CITY OF OREGON CITY PLANNING COMMISSION AGENDA

2. GLUA-20-00020: CU-20-00002 / SP-20-00043 - Adoption of Findings for Conditional Use Approval of Proposed 30-Bed Residential / Memory Care Facility at 182 Warner Parrott Road.

FINAL PLANNING COMMISSION FINDINGS AND NOTICE OF DECISION

FILE NUMBER: GLUA-20-00020: CU-20-00002 Conditional Use / SP-20-00043 Site Plan and Design Review

Figure 6. Original (top) vs. Revised (bottom) Left (East) Side Elevation – Not to Scale

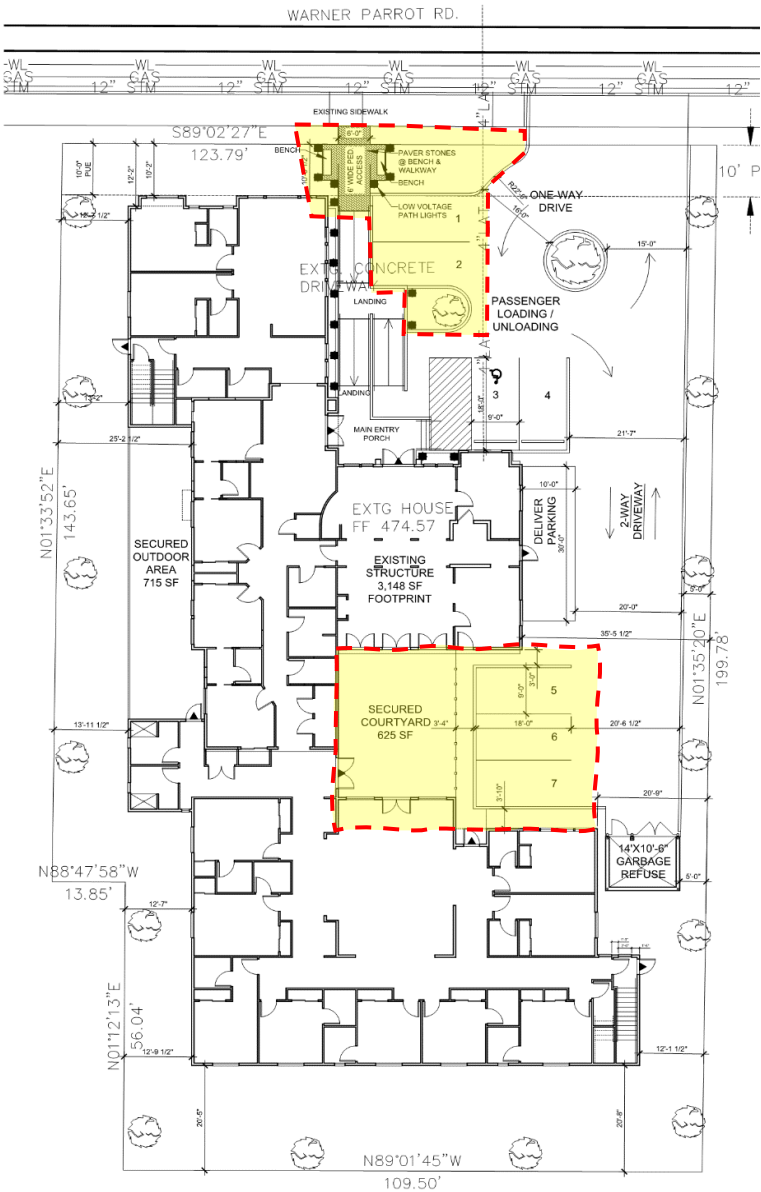
- Reduced the size to 17,240 square feet, and overall mass of the building by opening the center courtyard. This would have the effect of increasing the setback to the east side of the building in that location.
- Added additional off-street parking to 8 spaces to the maximum number of spaces allowed by the code, including one delivery parking space. With 4 available on-street parking spaces abutting the property the total spaces is available is twelve (12).
- Reduced lot coverage reduced slightly from 39% to 38%.
- Increased front window percentage to sixty percent.
- Revised landscaping due to increased off-street parking areas.

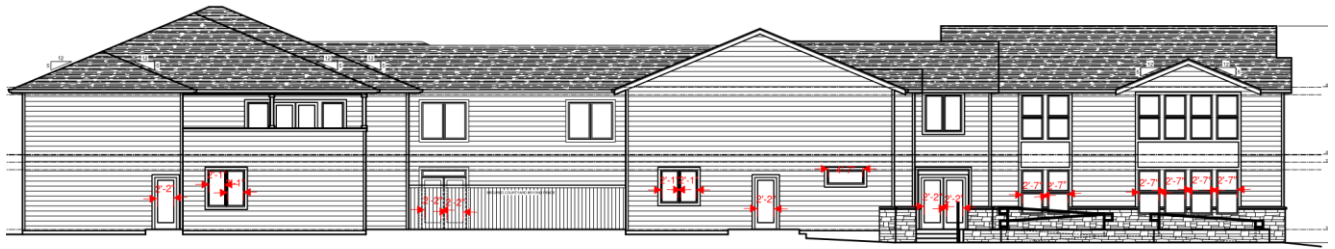
The east ground floor façade measures 169' 2 ½" in length. $169' 2 \frac{1}{2}" \times .3 = 50.7'$. The east ground floor facade requires 50.7' of windows between 3.5 feet and six feet from the ground. The applicant has

proposed 41.5' of windows (measuring glass only). *Based on this measurement, 9.2' of additional windows is required on the east ground floor front façade.*

35. Prior to issuance of a building permit the applicant shall provide revised plans that show 60% windows on the front ground floor façade and 30% on the sides. (P)

Ground floor façade (west or right side):

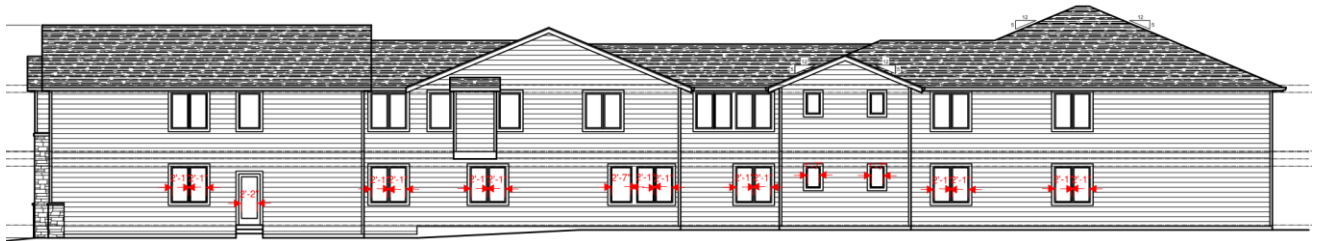
The west ground floor façade also measures 169' 2 1/2" in length. $169' 2 \frac{1}{2}'' \times .3 = 50.7'$. The west ground floor façade requires 50.7' of windows between 3.5 feet and six feet from the ground. The applicant has proposed 37'.025 of windows (measuring glass only). *Based on this measurement, 13.7' of additional windows is required on the west ground floor front façade.*

Figure 8. Original (top) vs. Revised (bottom) Front / North Elevation

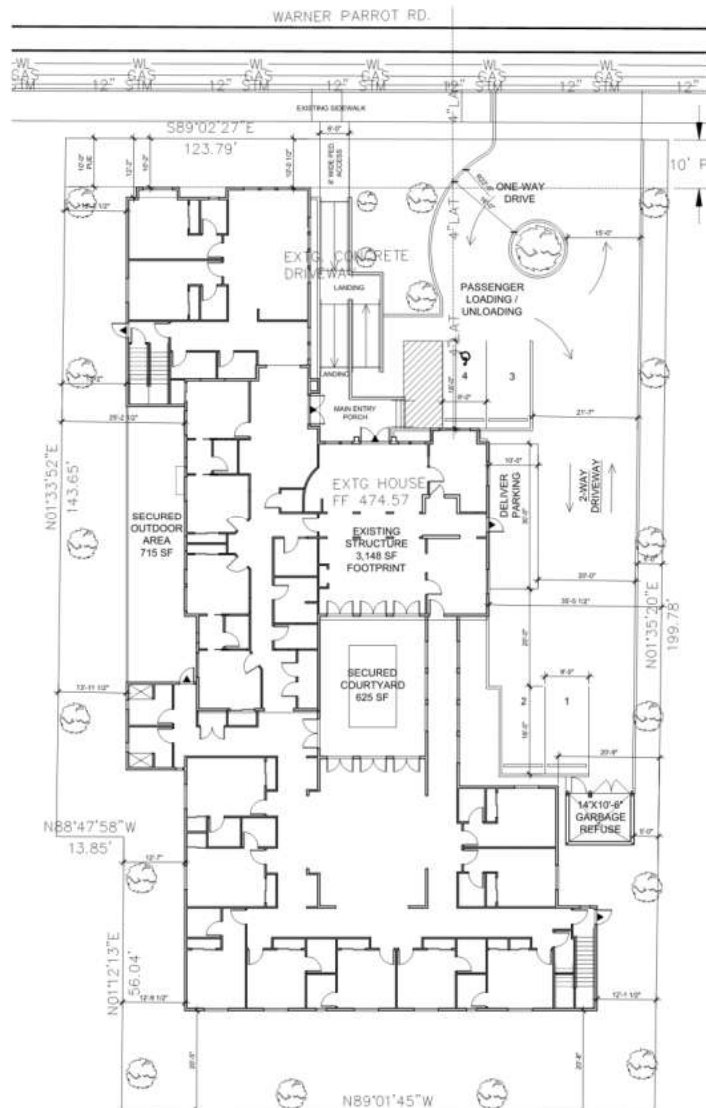
Added Windows to 60%

Figure 7. Original (top) vs. Revised (bottom) Right (west) Side Elevation – Not to Scale

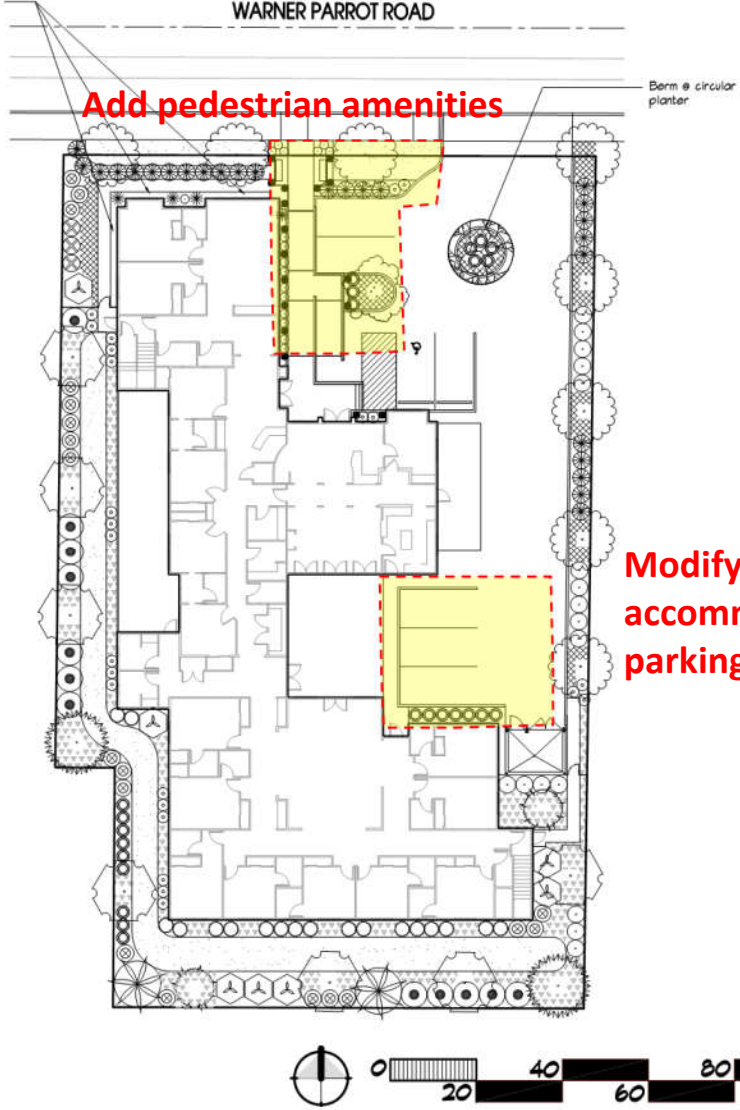
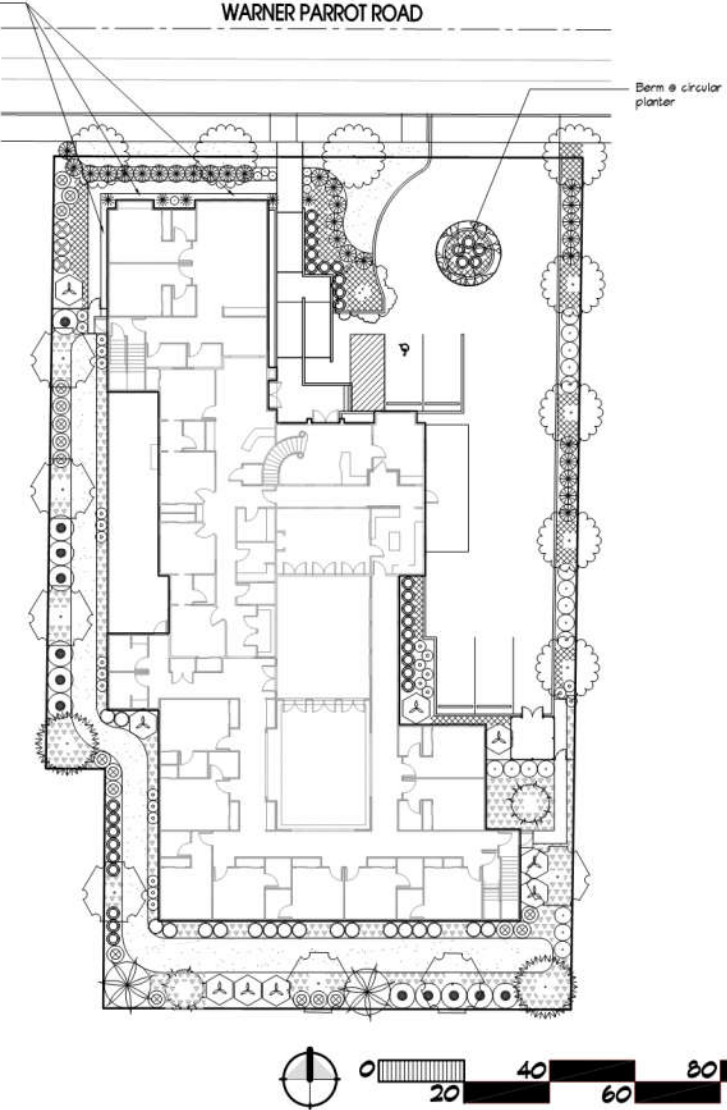
Remove roof peak

- a. Reduce the roof-pitch from 5/12 at the rear of the building
 - b. Plant additional evergreen screening trees at intervals no greater than 35' to appropriately screen the facility in all locations that are closer than 15 feet from the property line.

Requested Modification

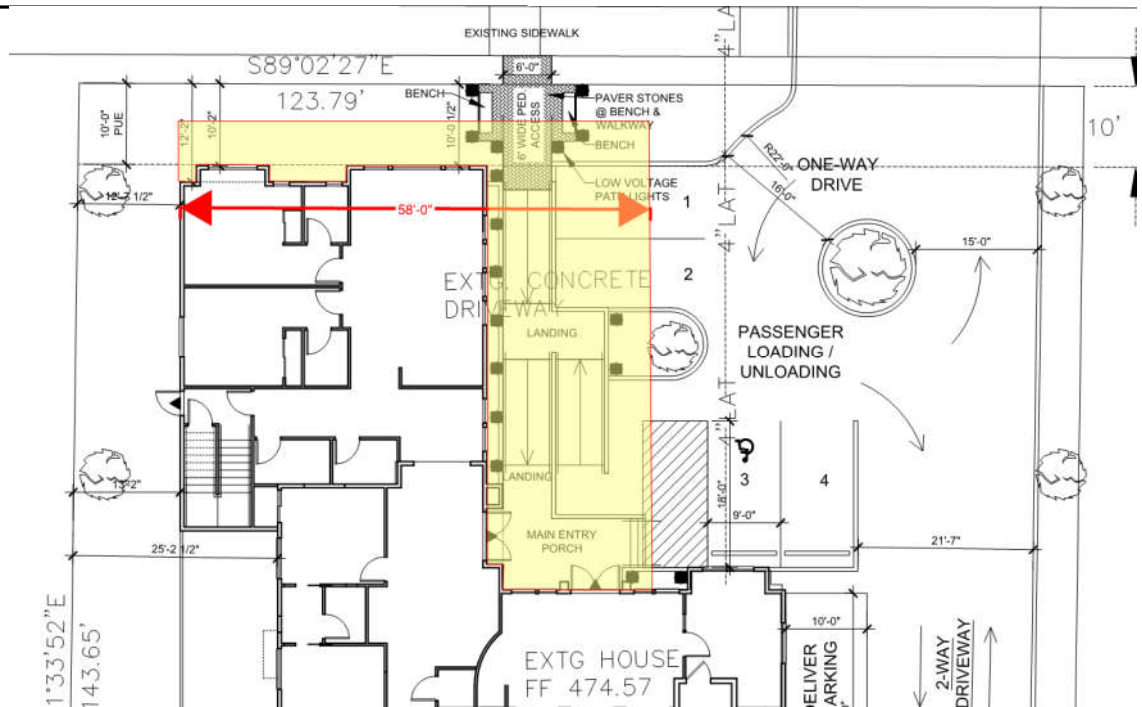
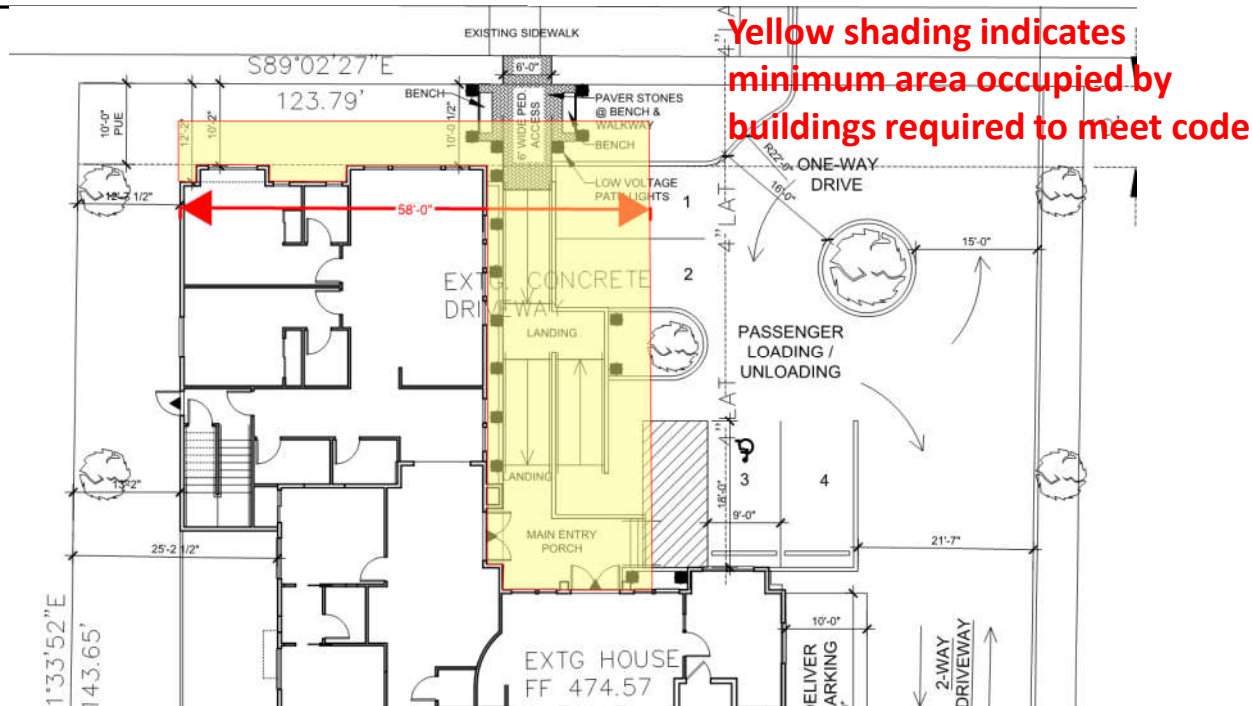
- OCMC 17.62.055.D. Siting of Structures - sixty percent of the site frontage width shall be occupied by buildings placed within five feet of the property line.
- Applicant requests modification of standard pursuant to OCMC 17.62.015.B.2

Yellow shading indicates minimum area occupied by buildings required to meet code

19. Per OCMC 17.62.055(D), the applicant shall provide a revised site plan indicating that at least sixty percent of the site frontage width shall be occupied by buildings placed within five feet of the property line prior to issuance of a building permit. (P)
